Proposal for Supplement 1 to the 06 series of amendments to Regulation No. 83 (Emissions of M₁ and N₁ vehicles)

Submitted by the Working Party on Pollution and Energy*

Annex 4, paragraph 6.1.3., amend to read:

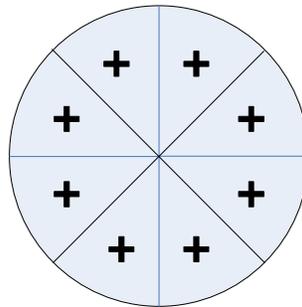
- (a) For blowers with rectangular outlets are located at the centre of each rectangle dividing the whole of the blower outlet into 9 areas (dividing both horizontal and vertical sides of the blower outlet into 3 equal parts).
- (b) For circular blower outlets, the outlet shall be divided into 8 equal arcs by vertical, horizontal and 45° lines. The measurement points lie on the radial centre line of each arc (22.5°) at a radius of two thirds of the total (as shown in the diagram below).

“6.1.3. A current of air of variable speed shall be blown over the vehicle. The blower speed shall be within the operating range of 10 km/h to at least 50 km/h, or as an alternative, at the request of the manufacturer, within the operating range of 10 km/h to at least the maximum speed of the test cycle being used. The linear velocity of the air at the blower outlet shall be within ± 5 km/h of the corresponding roller speed within the range of 10 km/h to 50 km/h. At the range over 50 km/h, the linear velocity of the air shall be within ± 10 km/h of the corresponding roller speed. At roller speeds of less than 10 km/h, air velocity may be zero.

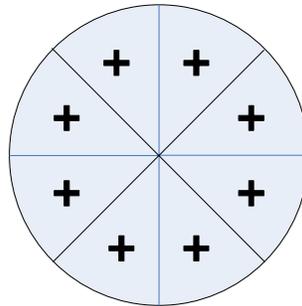
Annex 4a, paragraph 3.4.2., amend to read:

- (a) For blowers with rectangular outlets are located at the centre of each rectangle dividing the whole of the blower outlet into 9 areas (dividing both horizontal and vertical sides of the blower outlet into 3 equal parts).
- (b) For circular blower outlets, the outlet shall be divided into 8 equal arcs by vertical, horizontal and 45° lines. The measurement points lie on the radial centre line of each arc (22.5°) at a radius of two thirds of the total (as shown in the diagram below).

“3.4.2. A current of air of variable speed shall be blown over the vehicle. The blower speed shall be, within the operating range of 10 km/h to at least 50 km/h, or as an alternative, at the request of the manufacturer within the operating range of 10 km/h to at least the maximum speed of the test cycle being used. The linear velocity of the air at the blower outlet shall be within ± 5 km/h of the corresponding roller speed within the range of 10 km/h to 50 km/h. At the range over 50 km/h, the linear velocity of the air shall be within ± 10 km/h of the corresponding roller speed. At roller speeds of less than 10 km/h, air velocity may be zero.
